#### Division of Water Rights

Ground Water Well Monitoring Plan for Proposed Well #8b

TO: Marc Stilson, P.E., CPM, M.ASCE FROM: Jones & DeMille Engineering, Inc. PROJECT: Spanish Valley Culinary Water Project

RE: Ground Water Well Monitoring Plan

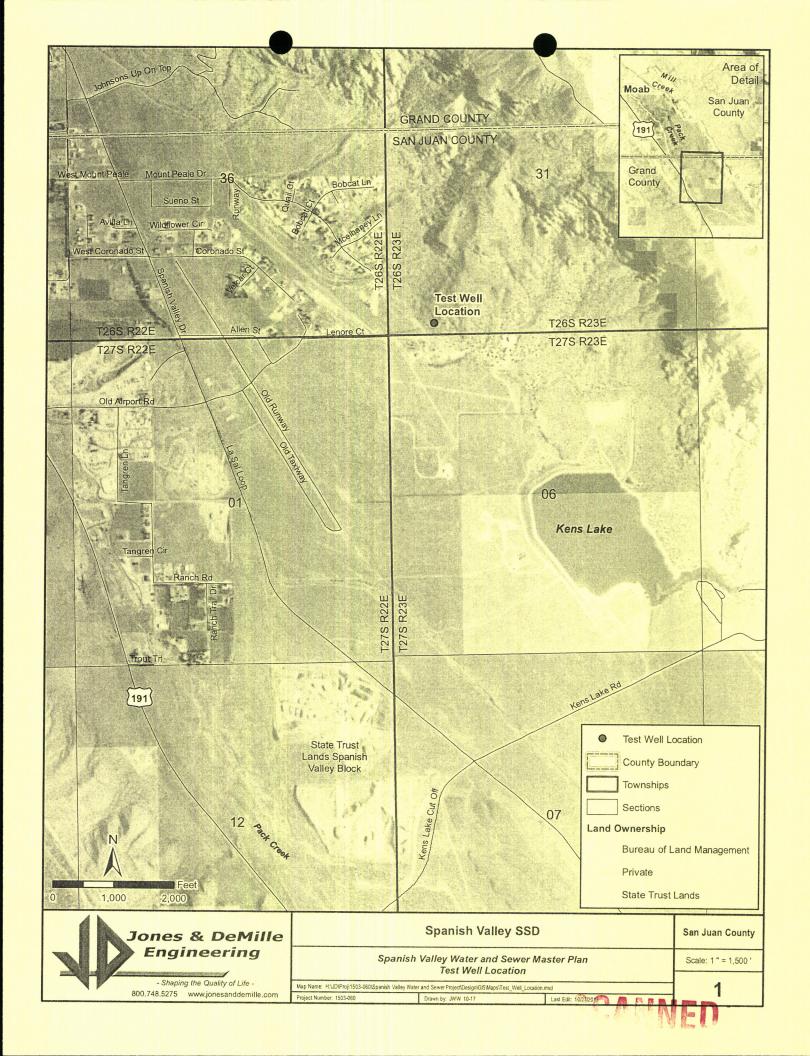
- 1. Before approval for use of this well as a production well, a constant rate pumping test shall be conducted for a minimum time period of one week in order to properly evaluate aquifer properties, aquifer yield, and determine the existence and possible extent of aquifer boundaries. Recovery data should also be collected and analyzed.

- 3. The driller shall collect drill cuttings at least every 10 feet (or more often with lithologic changes). The drill cuttings shall be submitted to the Division so they can be analyzed by the Utah Geological Survey.

- 7. We recommend that during drilling, the driller and/or onsite geologist pay special attention to determining exactly where and what depth intervals groundwater is entering the borehole. Borehole geophysical logging could also help in determining the exact water bearing zones. Moreover, after the pumping test and before the well is constructed a camera survey of the borehole should be conducted to verify geology and fracture/high permeability zones.
